United States Nuclear Regulatory Commission Official Hearing Exhibit	
In the Matter of:	CROW BUTTE RESOURCES, INC. (License Renewal for the In Situ Leach Facility, Crawford, Nebraska)
	ASLBP #: 08-867-02-OLA-BD01 Docket #: 04008943 Exhibit #: NRC-016-00-BD01 Admitted: 8/18/2015 Rejected: Other:
	Identified: 8/18/2015 Withdrawn: Stricken:

NUREG/CR-6870

Consideration of Geochemical Issues in Groundwater Restoration at Uranium In-Situ Leach Mining Facilities

Figure 12. Simulation 1 results. Oxic influent groundwater. Calcite and goethite initially present. Mass transfer coefficient = 10.

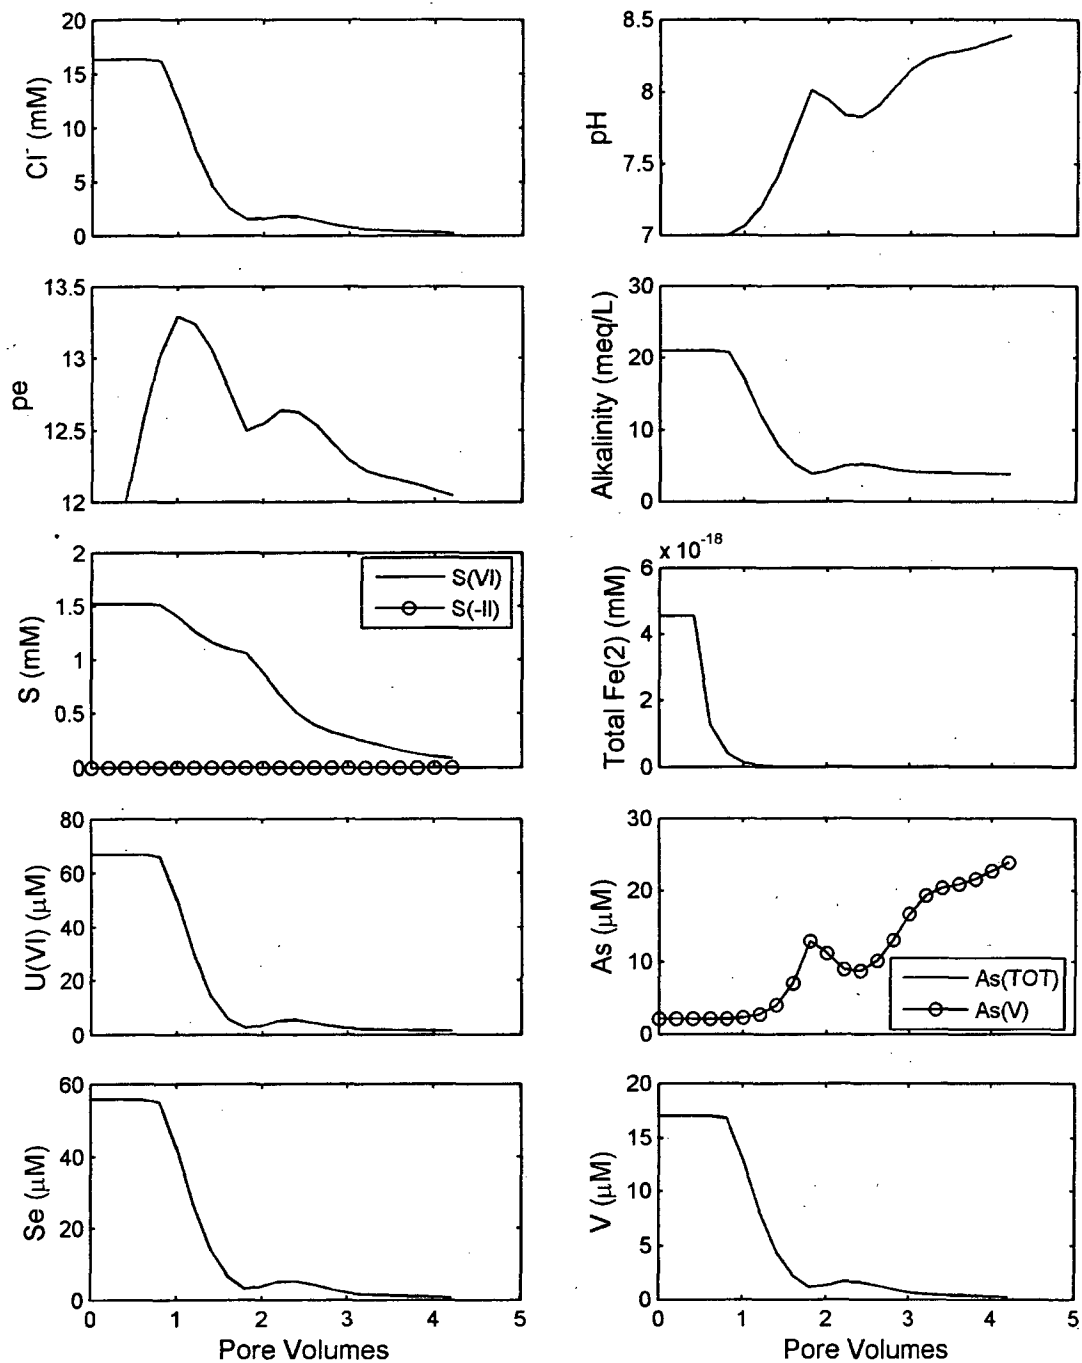
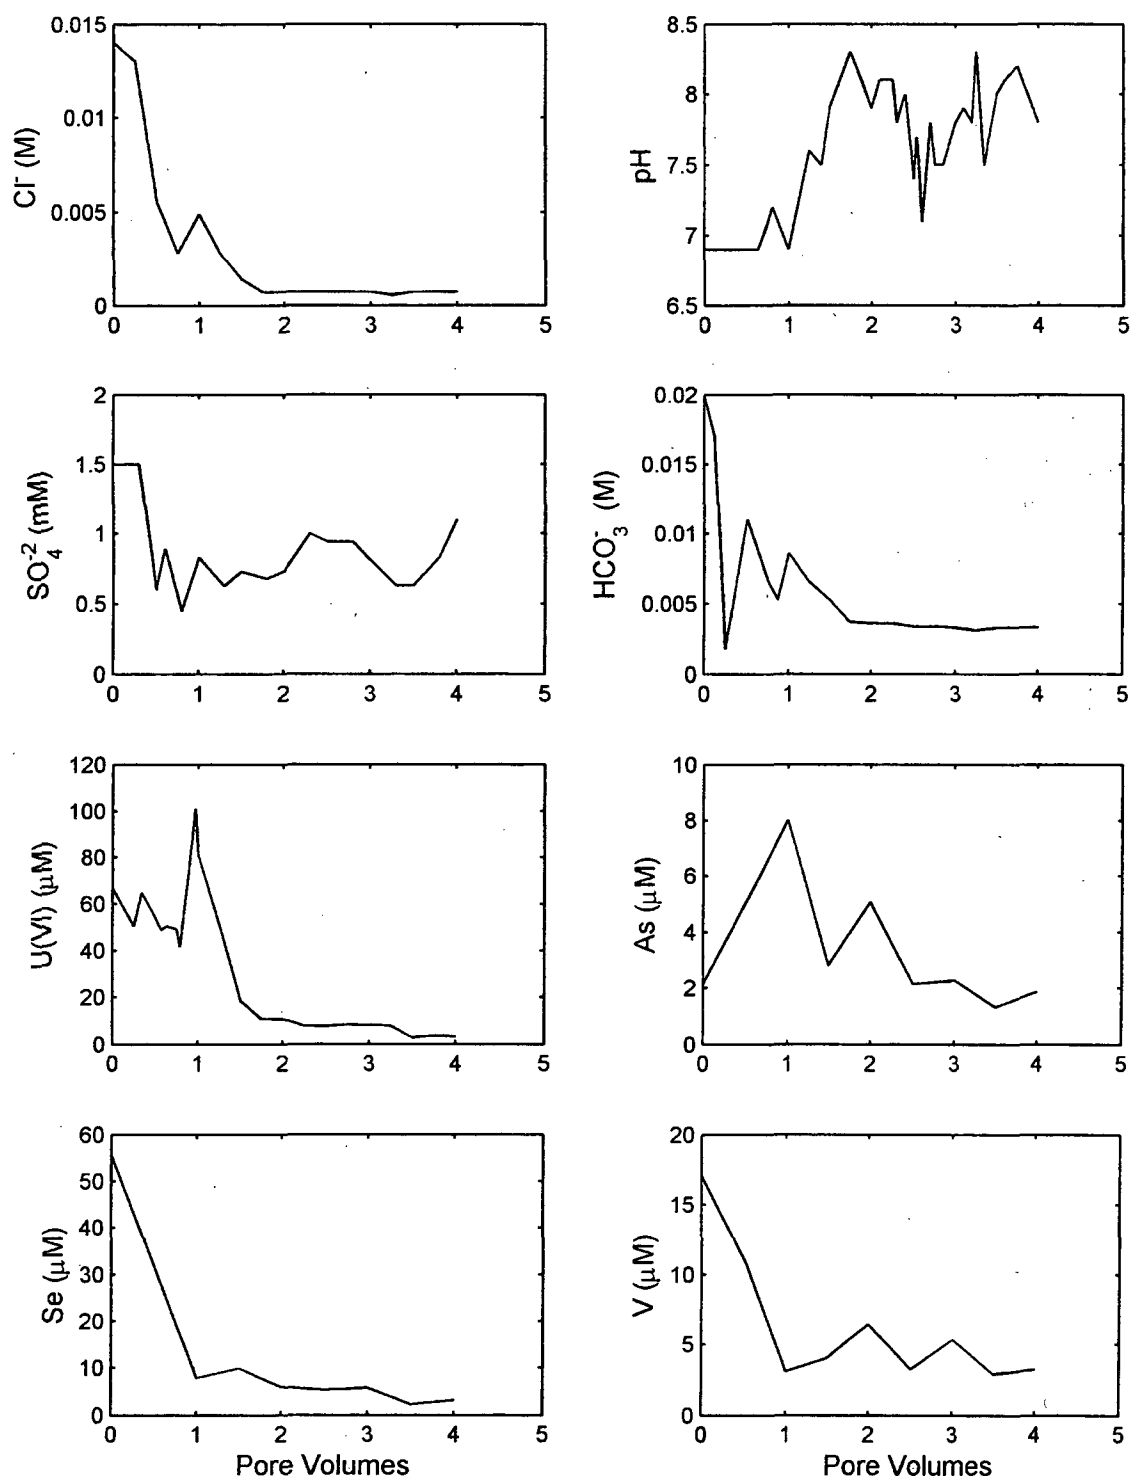
2-16. Comment: The results of Simulation 1 (Figure 12) are compared with the Ruth data (Figure 11). For illustrative purposes, it might be helpful to have another figure with the both the simulation results and the field data. Also, it would be helpful if the differences between the Ruth test and Simulation 1 were noted. For example, how many pore volumes were removed during ground water sweep during the Ruth test (and how was 'pore volume' defined for the Ruth test)?
